NEW YORK POWER AUTHORITY
FITZPATRICK STATION UNIT I

IEC LOOP DIAGRAM
REACTOR VESSEL LEVEL

THE DRAWING NUMBER OF THIS REPRODUCIBLE
IS 11825-LP-023-2B REV. 3A

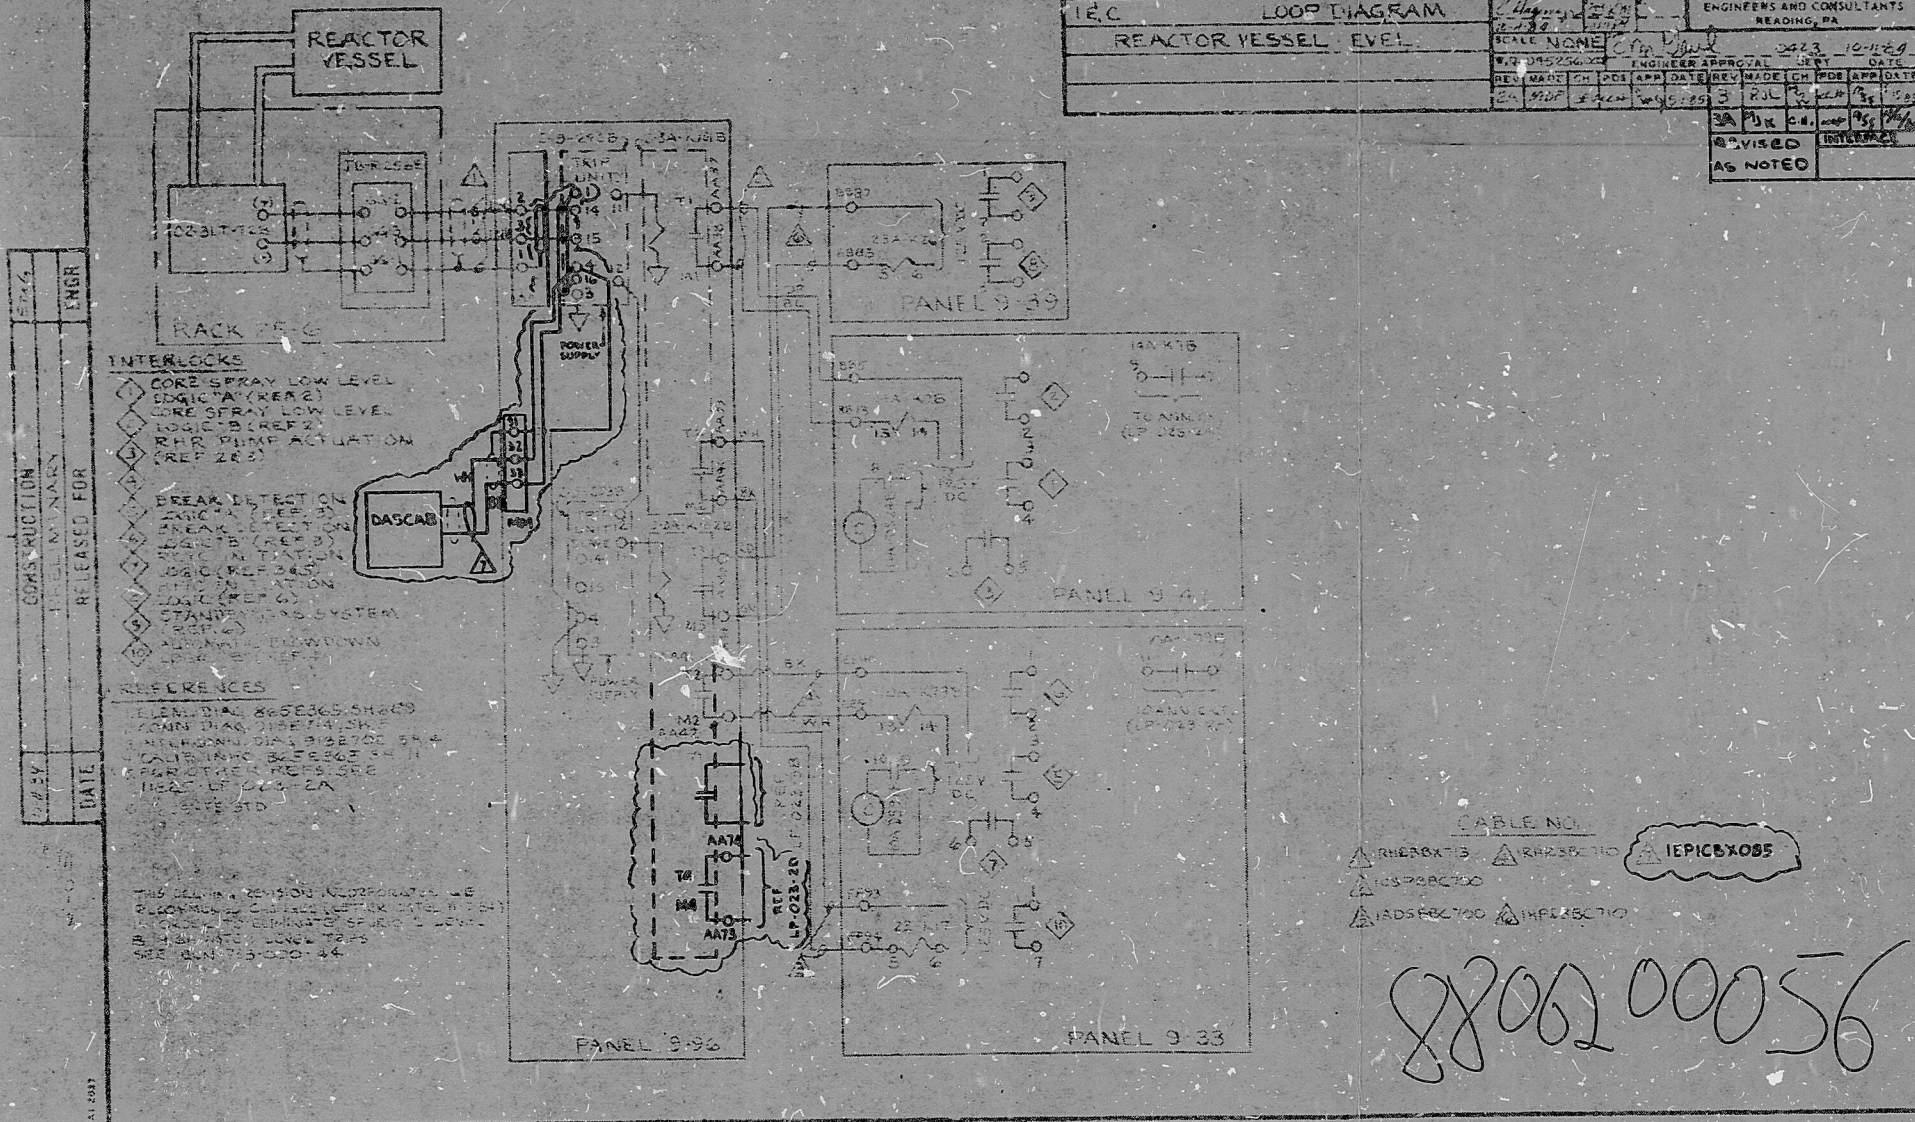
DATE	CHKD	DRAWING NO.	SH. NO.	REV		
11/23/83	JEV	11825-LP-023-2B		3A		
BY	ENGR	GILBERT ASSOCIATES, INC. ENGINEERS AND CONSULTANTS READING, PA				
DATE	CHKD	REV	MADE	CH	APP	DATE
11/23/83	JEV	3	RUL	JEV	JEV	11/23/83
REVISION	BY	DATE	DESCRIPTION	DATE	BY	DATE
3A	JEV	11/23/83	REVISED INTERLOCK			
AS NOTED

THIS DRAWING IS A REPRODUCIBLE REVISED
FOR MODIFICATION ATTS
MODIFICATION NO. #1-86-053 ORIGINAL
WILL BE REVISED UPON COMPLETION AND
VERIFICATION OF MODIFICATION.
